Our Ref: 14683-HISC-EJE RtS2 (rev.1)
Date: 9 March 2026

RE: **Response to Submissions 2 (RtS2) – Hunter Indoor Sports Centre (SSD-65595459)**

This architectural statement supports the Response to Submissions 2 (RtS2) for State Significant Development Application (SSD- 65595459) for the proposed Hunter Indoor Sport Centre (HISC) at 2 Monash Road and 24 Wallarah Road, New Lambton.

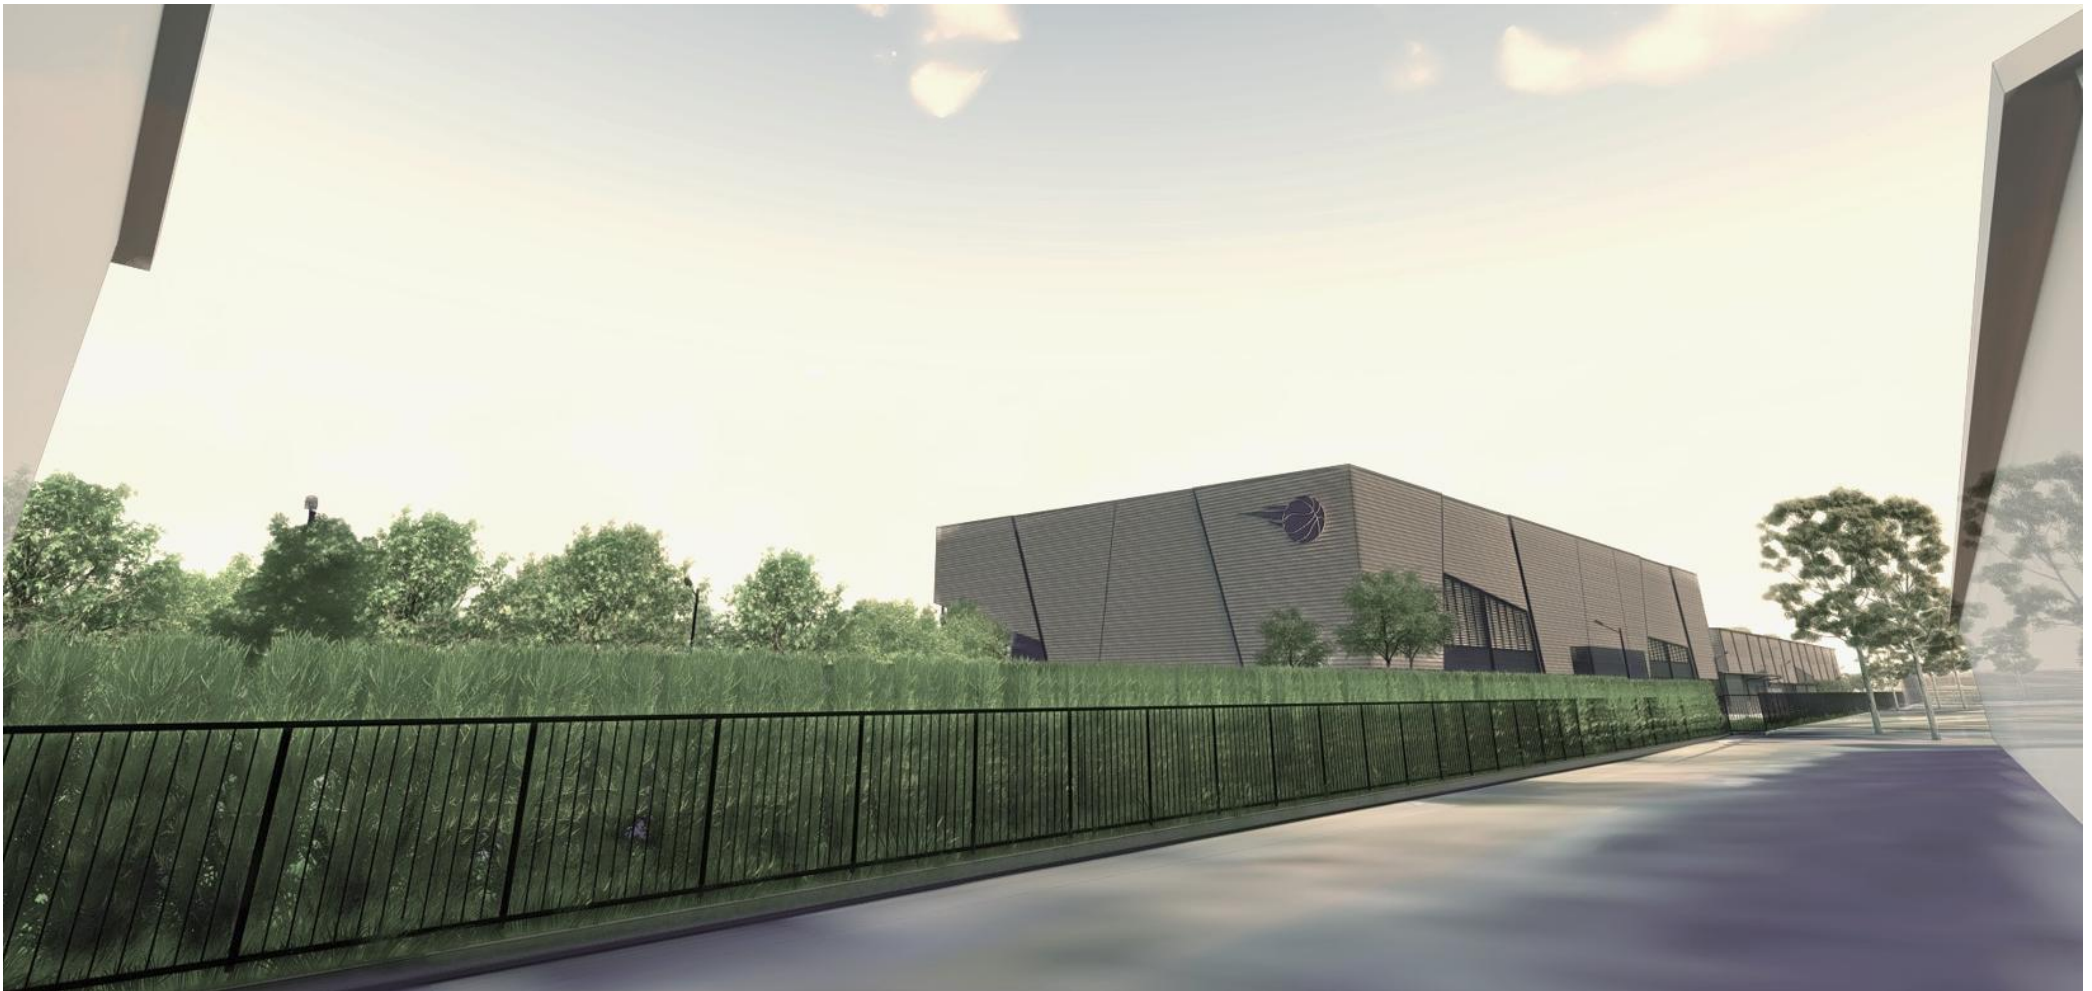
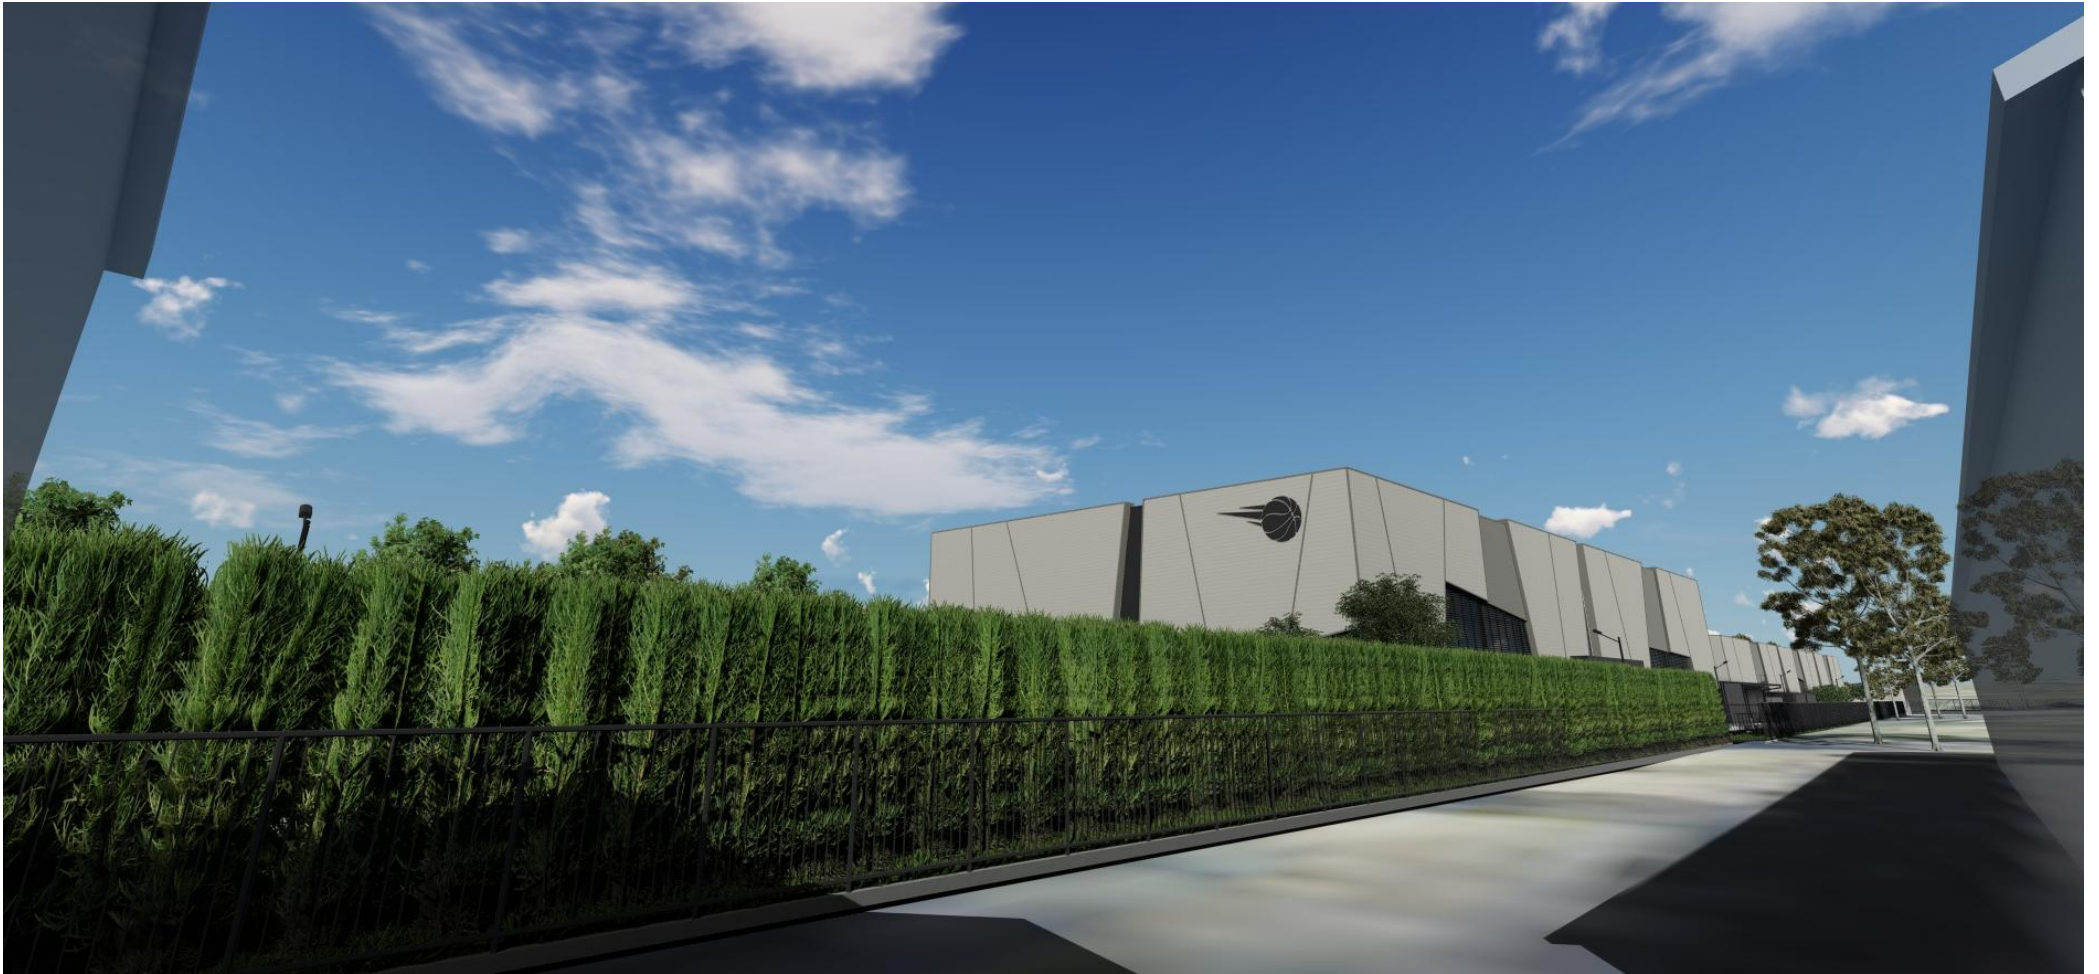
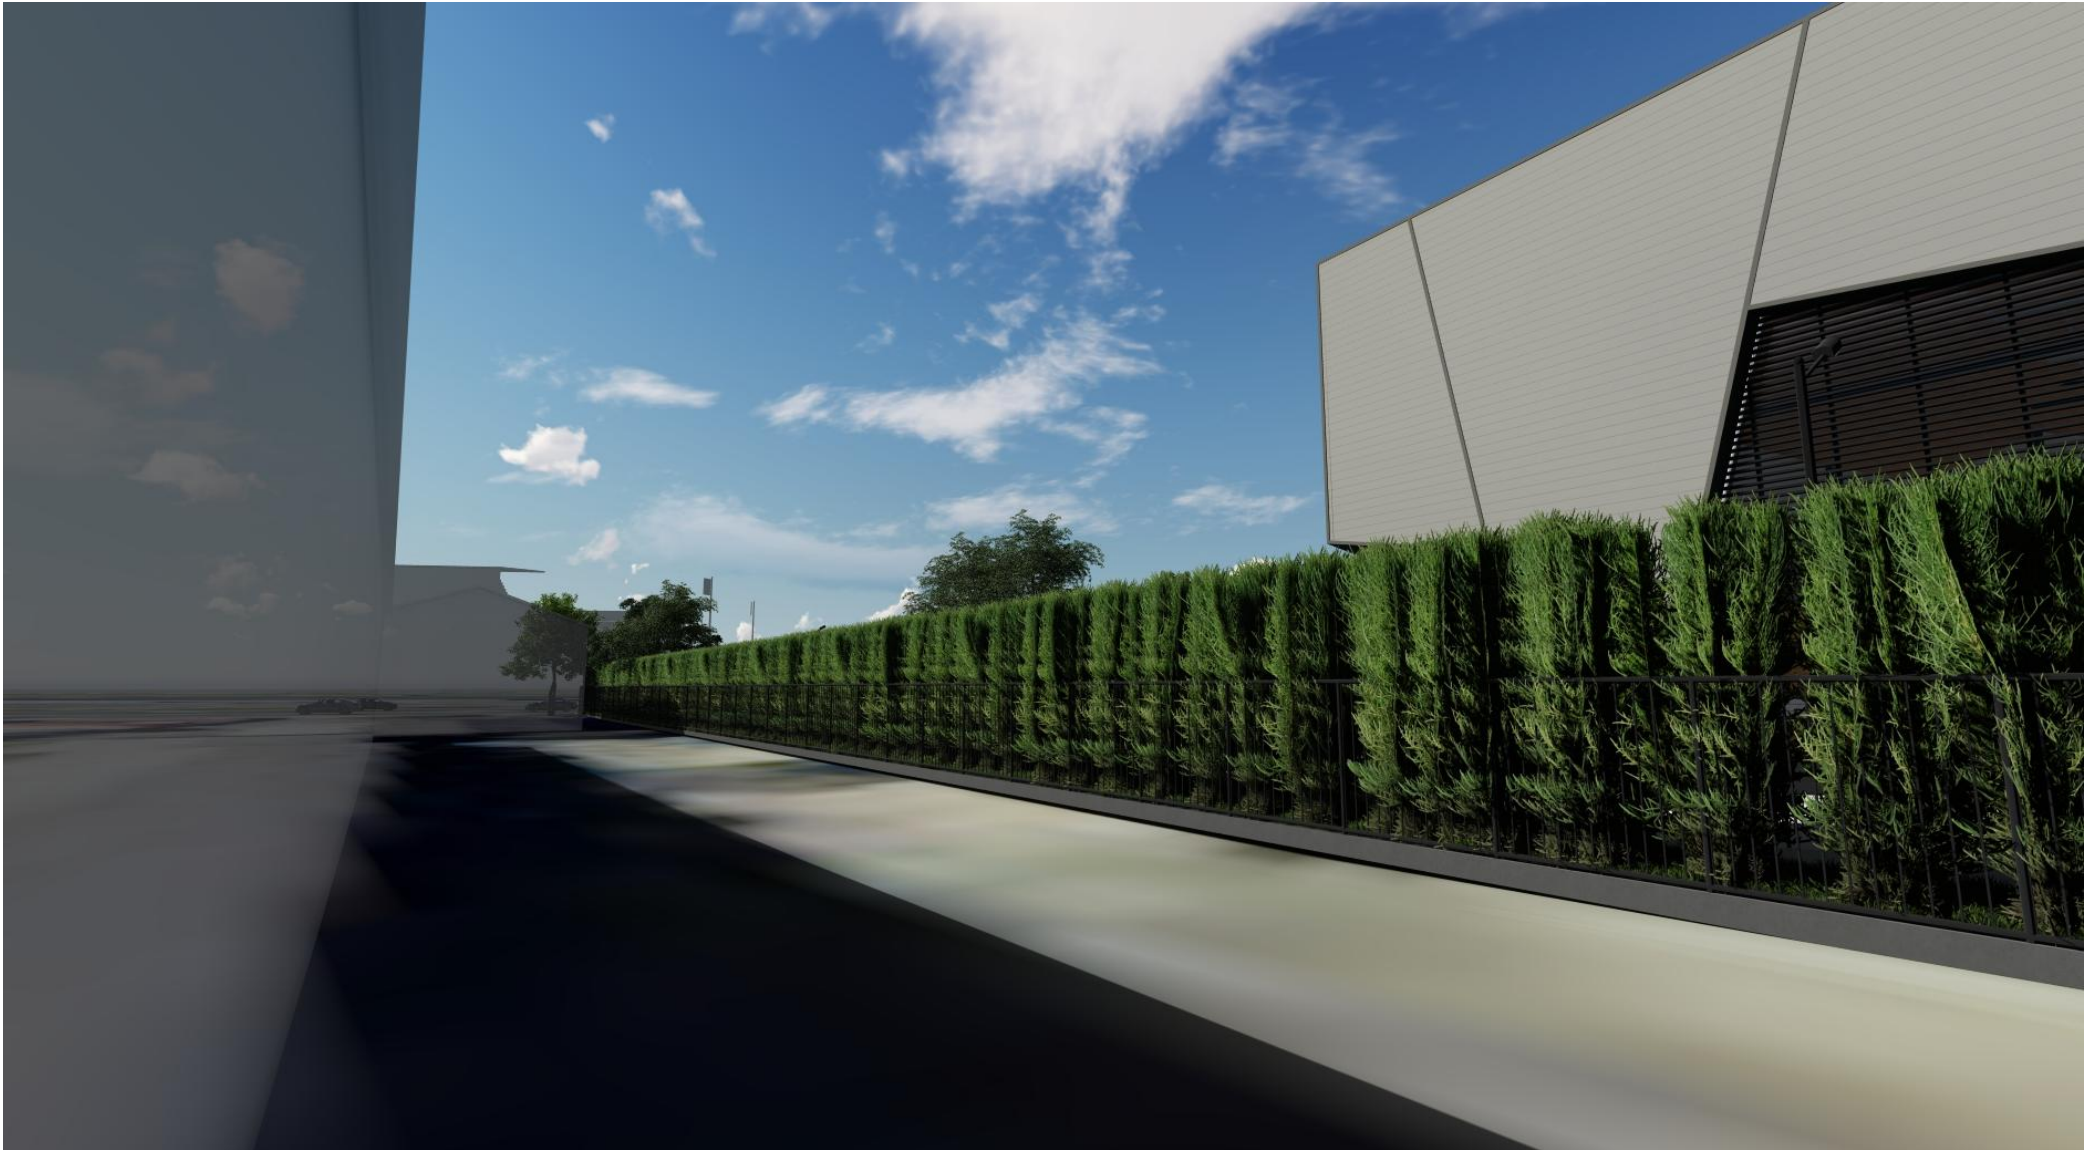
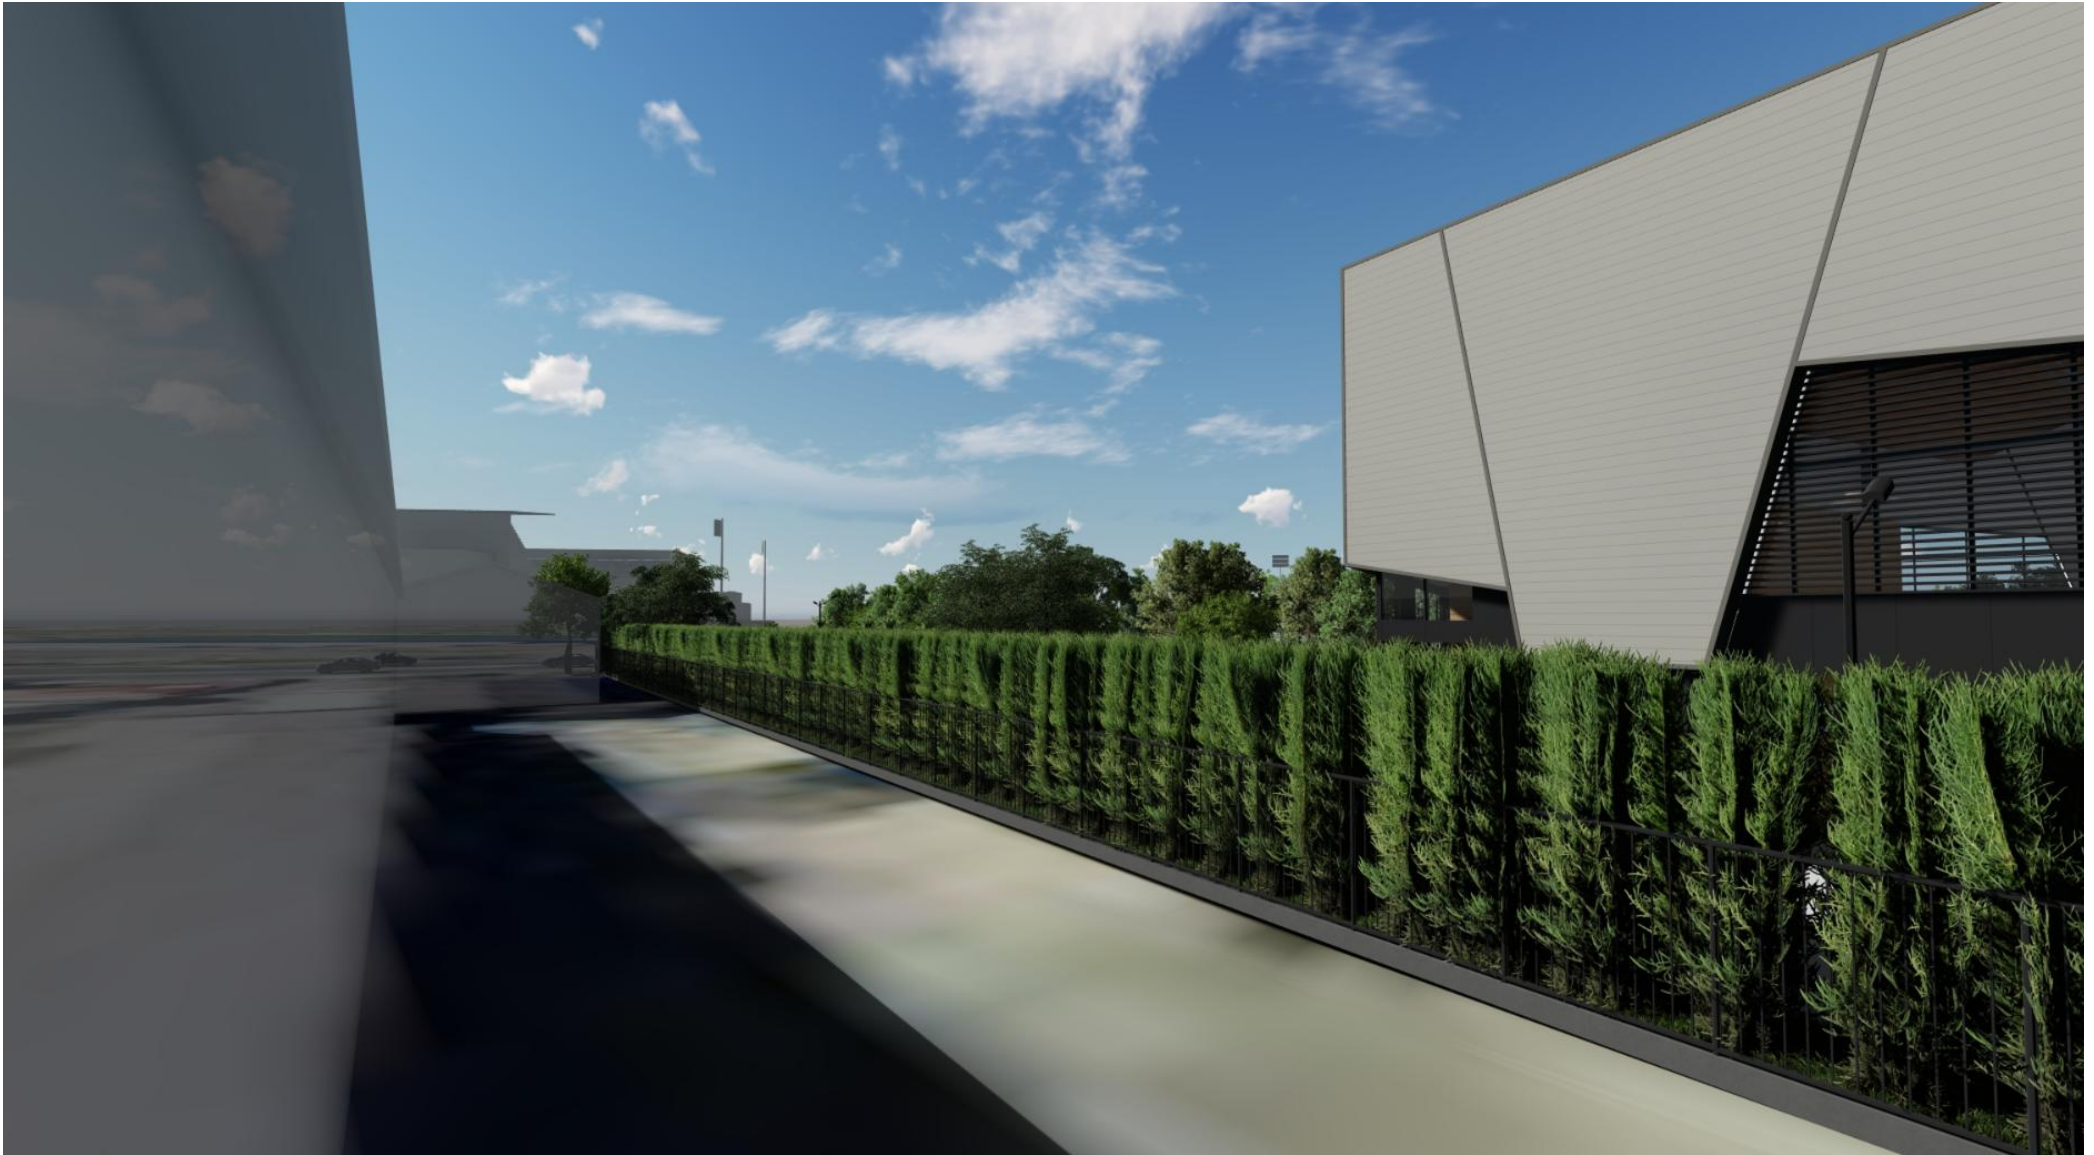
Develop the elevational treatment and articulation of the northern and western façades to provide an appropriate interface with the townhouses and school and reduce adverse visual impacts.

Regarding the SDRP comments to address visual impacts to the northern adjoining townhouses, extra landscape screening has been added, which was also at the request of CoN (Memo dated 25-09-2025). Refer to Fig.71 below (northern boundary cross-sections from Terras Landscape Architects).

Additional images have also been provided (see Figs 72-77 below), to assist with understanding the impact on the views from the existing adjoining townhouse north of the subject site. These images show that view-lines are still available to the south & south-east (particularly from the upper floors) & also show the landscape screening proposed along the boundary, that has been requested by Council.
